PLAN REVIEW SHEET

Telephone: 704-353-0018 **Petition:** 2014-049

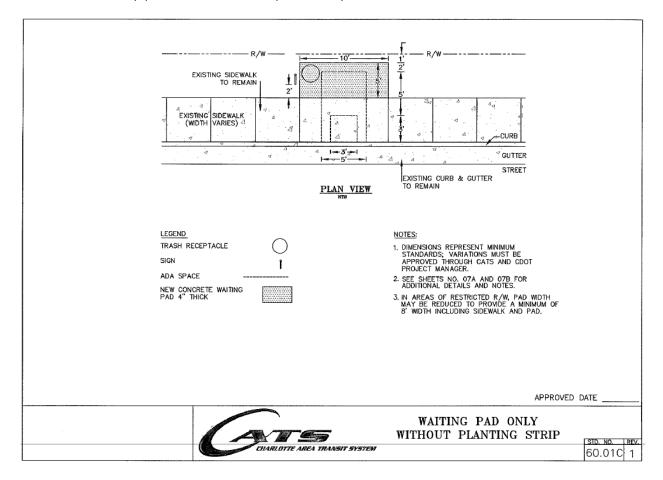
The Petitioner is requested to retain the existing bus stop and waiting pad along Morrison Boulevard. If the any sidewalk or curb construction is required along Morrsion Boulevard, then the Petitioner is requested to upgrade the existing bus waiting pad to the attached standard. The bus stop may move in order to avoid impacting any of the existing mature trees to be preserved. Below is an image of the standard detail (60.01B) for the requested bus stop pad.

The site plan may either show the conceptual location of the bus stop on Morrison Boulevard, or alternatively, include a development note to locate the bus stop pad during the development review and permitting process.
